Metropolitan Historic Zoning Commission
Sunnyside in Sevier Park
3000 Granny White Pike
Nashville, Tennessee 37204
Telephone: (615) 862-7970
Fax: (615) 862-7974

STAFF RECOMMENDATION
2700 Oakland Avenue
December 16, 2020

Application: New Construction—Addition
District: Belmont-Hillsboro Neighborhood Conservation Zoning Overlay
Council District: 18
Base Zoning: R8
Map and Parcel Number: 11704016700
Applicant: Brittney Mount, Allard-Ward Architects
Project Lead: Jenny Warren, jenny.warren@nashville.gov

<p>Description of Project: This application is for a rear addition that steps wider and a side addition.</p> <p>Recommendation Summary: Staff recommends approval with the following conditions:</p> <ol style="list-style-type: none">1. Staff approve the final windows, doors, brick and roof color prior to purchase and installation; and2. The HVAC shall be located behind the house or on the either side, beyond the mid-point of the house. <p>With these conditions, staff finds that the application meets Sections II.B and V of the design guidelines for the Belmont-Hillsboro Neighborhood Conservation Zoning Overlay.</p>	<p>Attachments</p> <ul style="list-style-type: none">A: PhotographsB: Si

Figure 2: Existing rear screened porch to be removed.

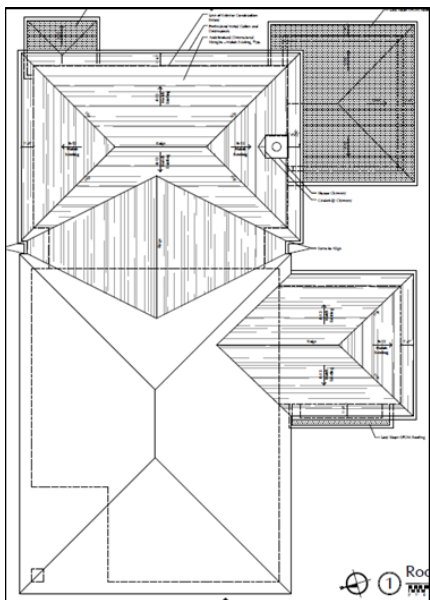
Partial Demolition: The application proposes removal of an existing shed-roofed screened porch at the rear (Figure 2). The porch is not architecturally significant, and staff finds that its removal meets the guidelines for demolition. Selective portions of the rear and right-side walls will also be removed to accommodate the new additions. The removal of these portions of wall will not affect the historic or architectural integrity of the historic house. Staff finds that the proposed partial demolition meets Section V.2 of the design guidelines for appropriate demolition and does not meet Section V.1 for inappropriate demolition.

Figure 5: Interior side elevation

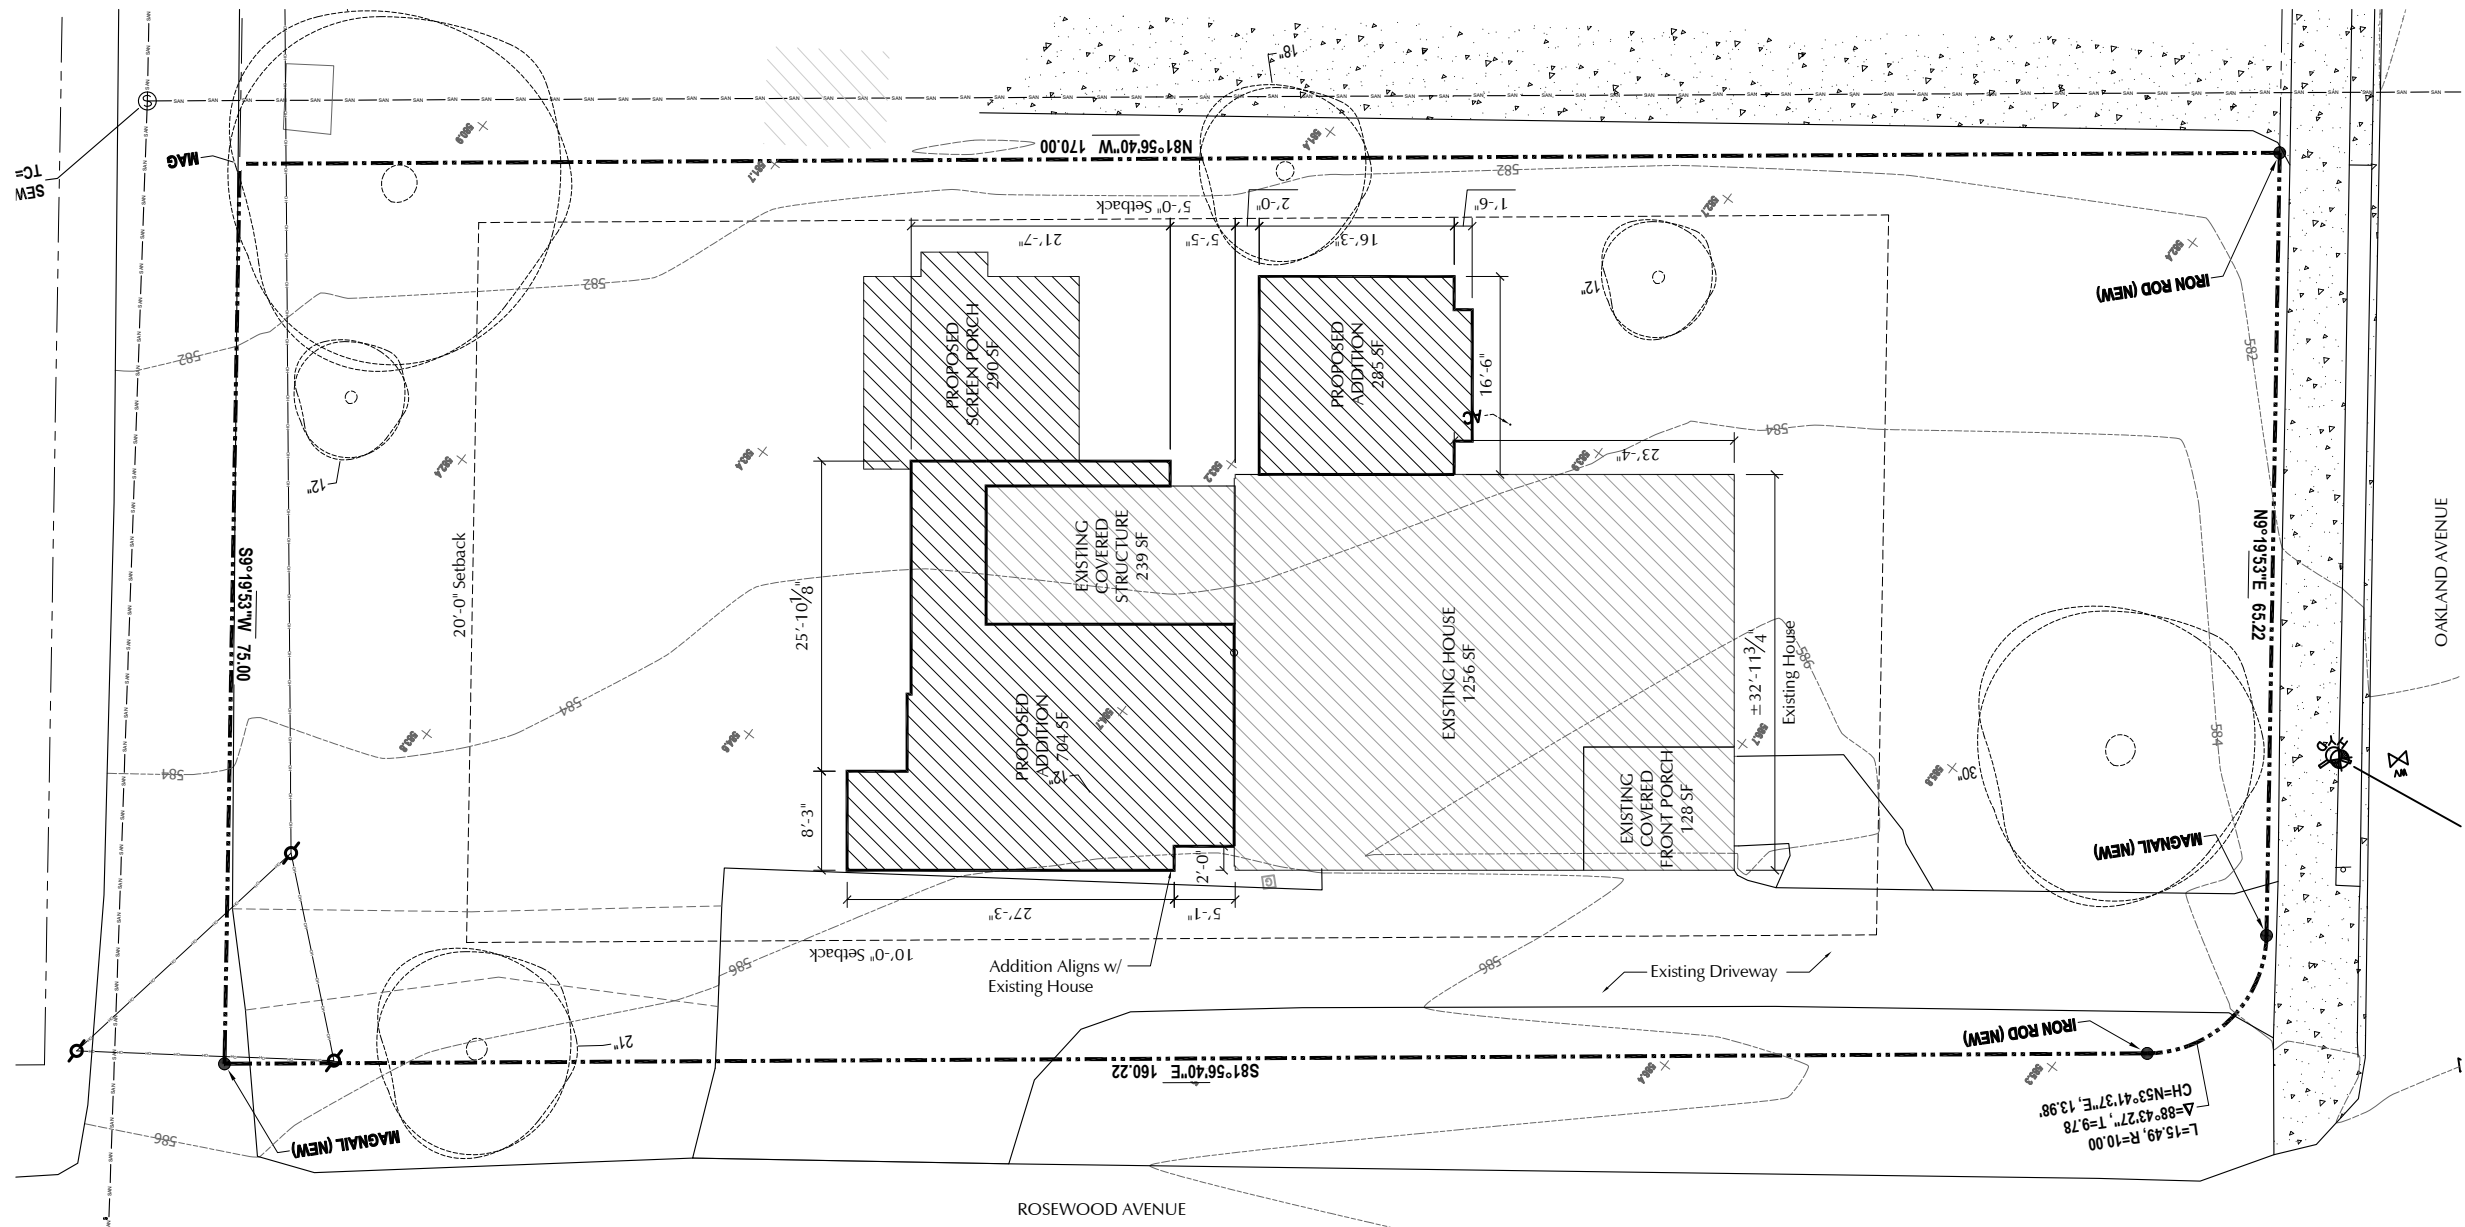
Roof form: The existing house has a hipped roof with 8/12 pitch. The rear addition connects to the house with a low-sloped 4/12 connection, and both the side and rear additions have hipped roofs with an 8/12 slope. The screened porch and rear vestibule are both hipped with a very low 1/12 slope, which is appropriate for these areas. Staff finds that the proposed roof forms are compatible with the historic house and meet Section II.B.1.e.

Proportion and Rhythm of Openings: The submitted plans indicate no changes to the window and door openings on the existing house. The windows on the proposed addition are generally twice as tall as they are wide, meeting the historic proportions of openings. There are smaller almost squared windows on the side elevations, but there are windows of similar proportions on the side elevations of the historic house, so staff finds these to be appropriate. There are no large expanses of wall space without a window or door opening. Staff finds the project's proportion and rhythm of openings to meet Section II.B.1.g.
